Department initiated Amendment

Licence Number	L6831/1997/12
Licence Holder	Shire of Collie
File Number	DER2017/000540-1
Premises	<p>Gibbs Road Putrescible Landfill Gibbs Road COLLIE WA 6255</p> <p>Legal description – Lot 500 on Deposited Plan 76826</p> <p>As defined by the Premises map attached to the Revised Licence</p>
Date of Report	15 October 2024
Decision	Revised licence granted

Figure 1: Groundwater monitoring bore locations (New bore locations proposed by Licence Holder shown in pink and DWER recommended locations shown in yellow)

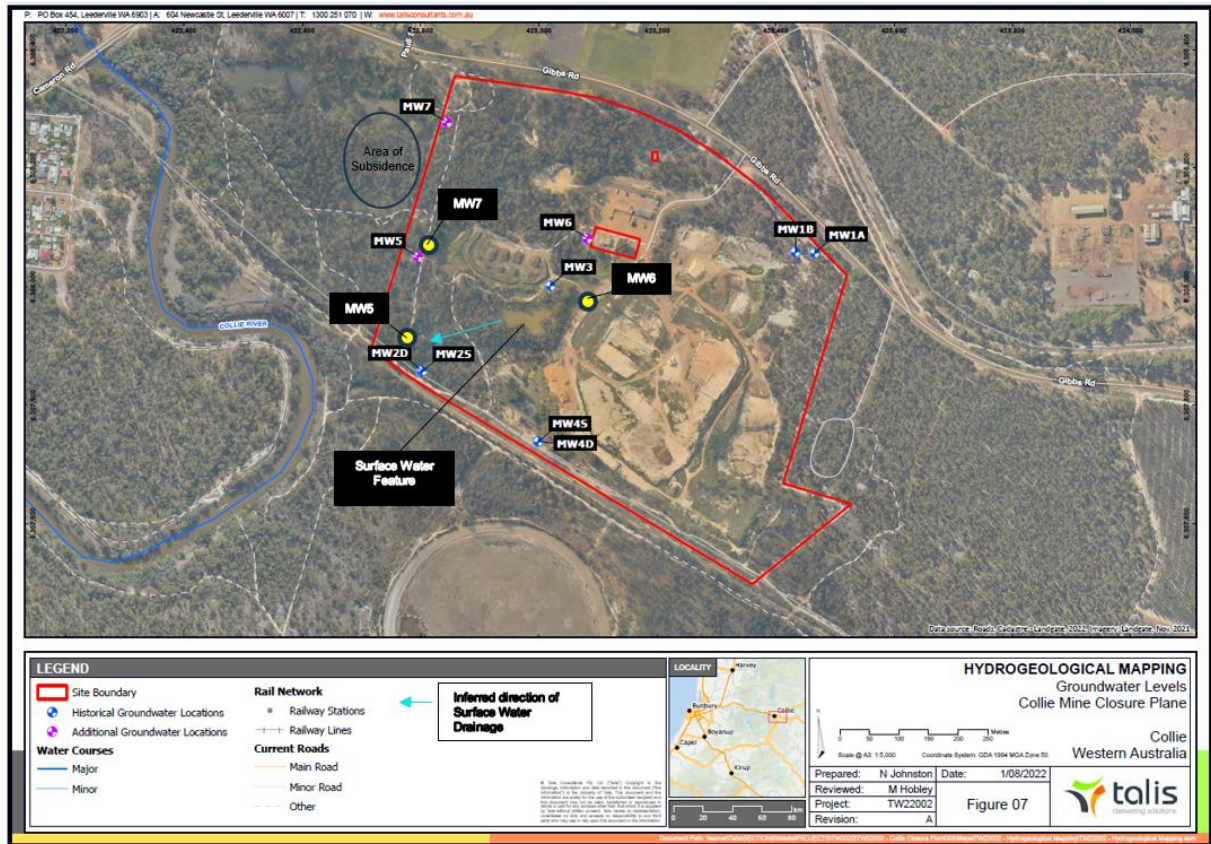
Whilst some of the deficiencies in the Groundwater Monitoring Plan and Hydrogeological Report can be addressed outside of this licence amendment, the department has determined the installation of new groundwater monitoring bores and changes to the existing monitoring network to be a priority due to the potential for contaminant migration from the landfill to the Collie River. The department does not consider the proposed locations of the additional groundwater monitoring bores in the submitted Groundwater Monitoring Plan and Hydrogeological Report to be suitable. This is due to the following reasons:

- The inferred groundwater flow direction is potentially biased in the north direction due to the inclusion of groundwater elevation at MW3. The screen of MW3 penetrates a mine void, and therefore, data collected from this bore is not representative of aquifer conditions. The proposed location of MW6 and MW7 is potentially too far north to assess leachate pathways.
- The surface water feature shown in Figure 1 and associated drainage to the Collie River may have been overlooked. Therefore, MW5 and MW2 may not capture the potential leachate pathway from the landfill to the Collie River.
- The report provides limited justification and detail on the proposed design of the bores.

The department has determined multilevel installations (one shallow well and one intermediate depth well) at each of the three locations, shown as yellow dots in Figure 1, to be appropriate to assess potential impacts from the landfill and assess groundwater flow and interactions beneath the premises. However, an on-ground assessment and review of mine adit locations should be conducted before drilling the bores. The department provides the following justifications for the new locations and number of bores:

- The new location of bore MW5 in the southwest corner of the site will assess potential leachate pathways near the drainage path of the surface water feature to the Collie River. This bore location will also supplement the lithological information missing in the area.

- The new location of bore MW6 central to the site, places it closer to landfill operations and upgradient to the surface water feature. It will also improve interpretations near existing bore MW3.

- The location of bore MW7 is a downgradient of landfill features such as sumps and the pyrolysis plant.
- The installation of one shallow well and one intermediate depth well at each new monitoring location will allow for the detection of shallow and deep contamination and assessment of vertical hydraulic gradients along the western boundary and central to the premises. Installing the shallow screen across the water table at these locations would allow for the detection of Light Non-Aqueous Phase Liquids (LNAPLs).
